## Meeting Agenda Plat Committee

Monday, October 11, 2021

1. [KPB-3597](#) Alaskan Wildwood Phase 2  
KPB File 2021-127  
*Attachments:* [1. MAP Vicinity](#)  
[2. MAP Aerial Map Zoomed In](#)  
[3. Plat Prelim KPB 2021-127 Reduced](#)  
[4. Staff Report Alaskan Wildwood Phase 2 KPB 2021-127](#)  
[5. MAP Aerial 3](#)  
[6. MAP Aerial Map Zoomed Out](#)  
[7. MAP Contour](#)  
[8. MAP Section Line Easement](#)  
[9. MAP Wetlands](#)  
[10. Plat Parent HM 2000-48](#)  
[11. Plat Parent HM 2000-31](#)
2. [KPB-3598](#) ASLS No. 2017-23 Tract A B C D & E  
KPB File 2021-133  
*Attachments:* [1. MAP Vicinity](#)  
[2. MAP Aerial](#)  
[3. Plat Prelim KPB 2021-133 Reduced](#)  
[4. Staff Report ASLS 2017-23 Tracts A-E 2021-133](#)  
[5. Plat Parent SW2001-10](#)  
[6. Plat parent SW 1998-03](#)

SHEET: 3 OF 6

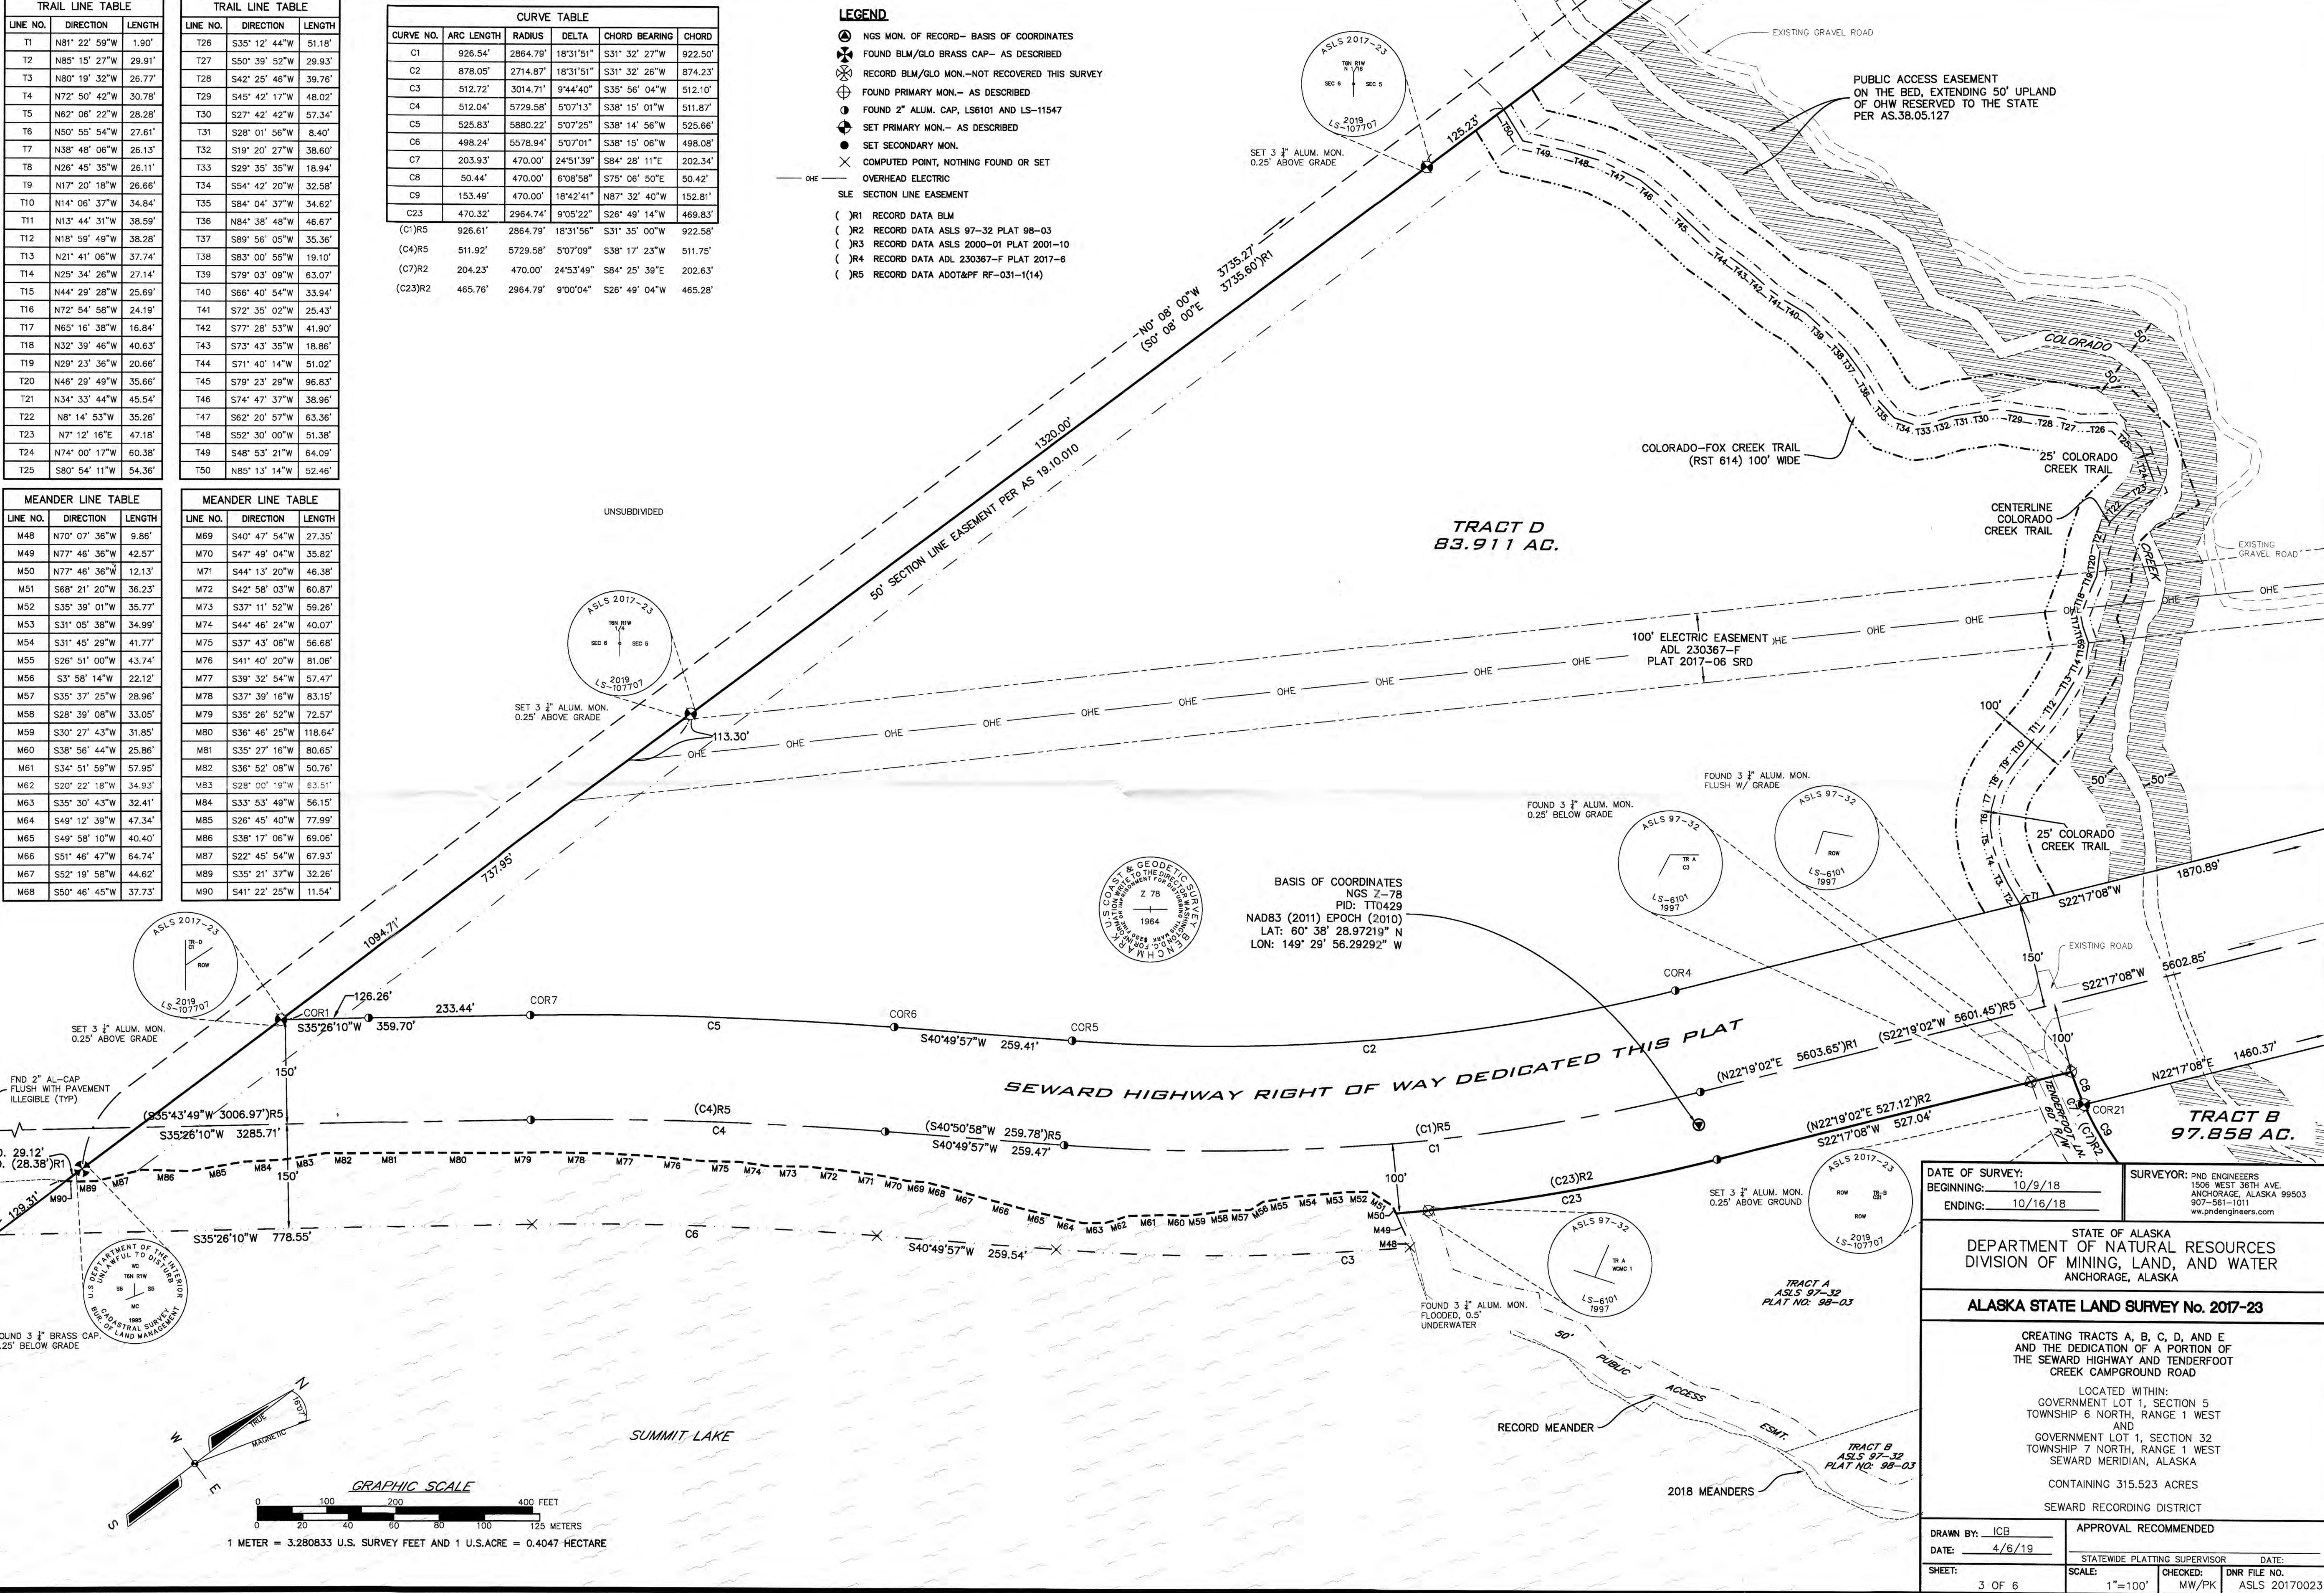
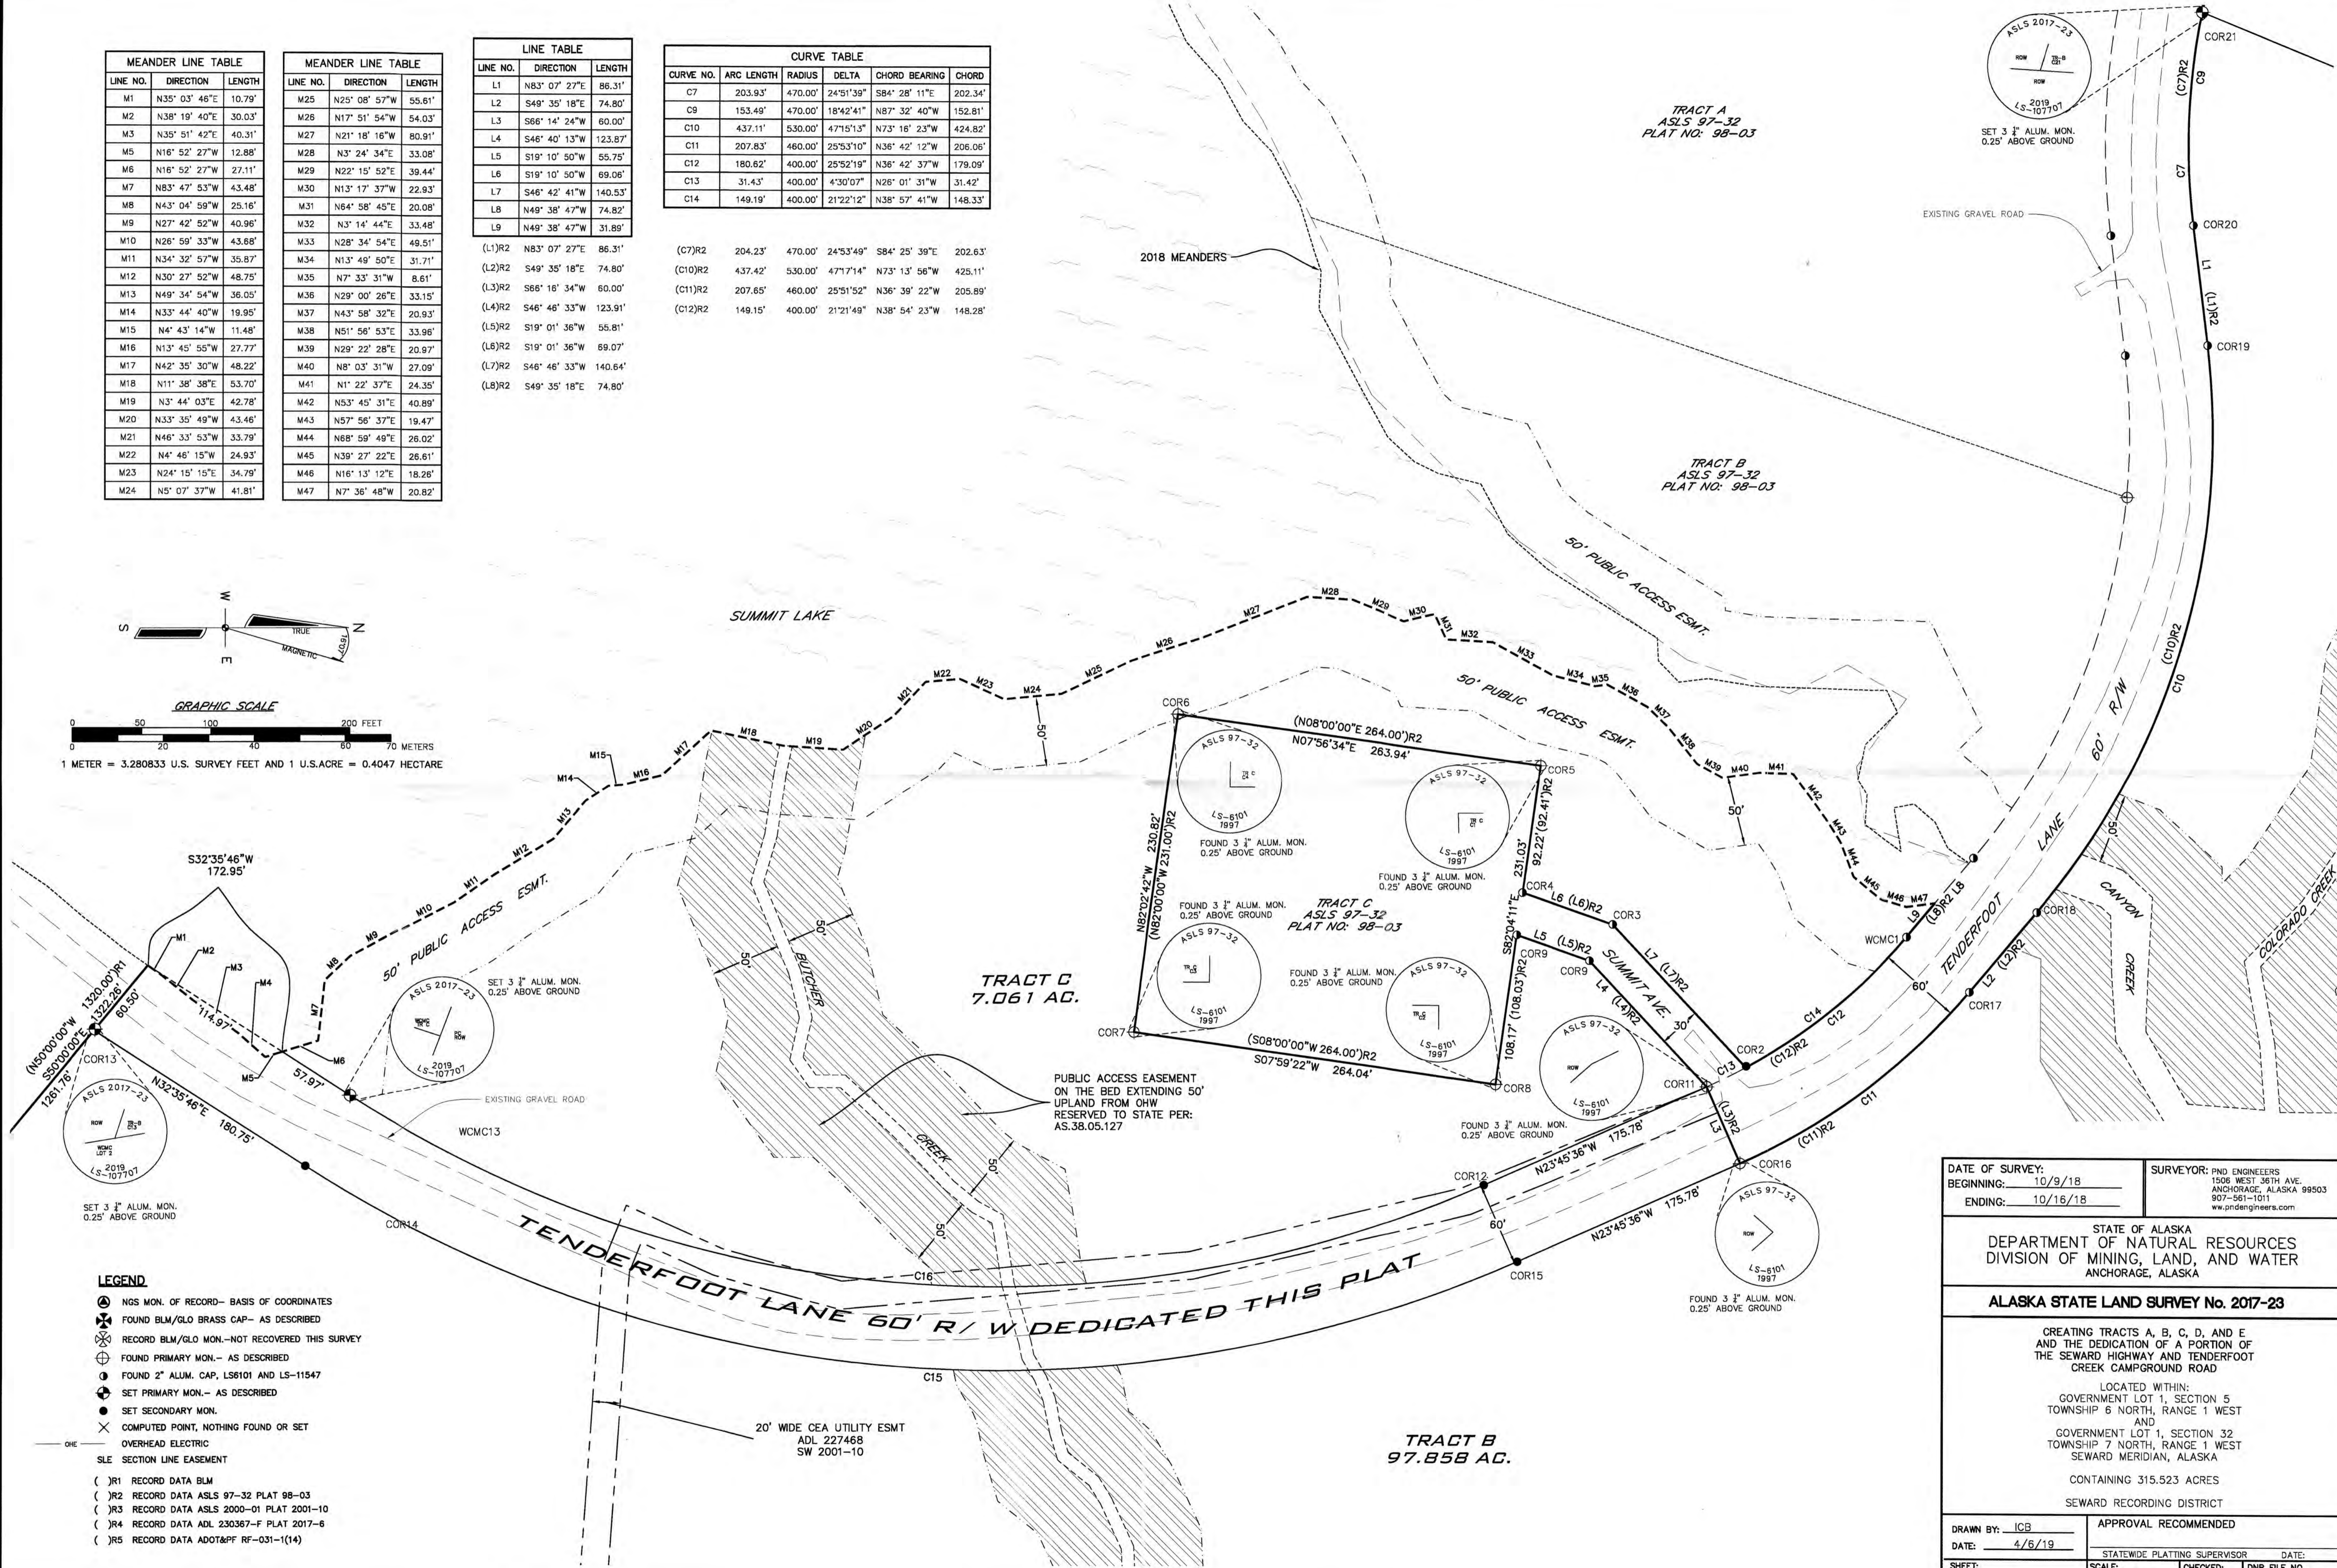
*Sheet 1 – Add a plat note that the subdivision is within the Chugach National Forest Boundary.*

*Sheet 4 – Neighboring Tract B of ASLS 97-32 is shown with a 50 foot public access easement along Summit Lake all the way to Tenderfoot Lane. Per the ASLS 97-32, the easement ends at the meander point between S 44° 36' 10" W and S 34° 50' 05" W. Revise the depiction or provide documentation that the public access easement is for the full length of Tract B.*

*Sheet 5 – Depict and label the 50 foot section line easement located along the east and southern boundary of proposed Tract A.*
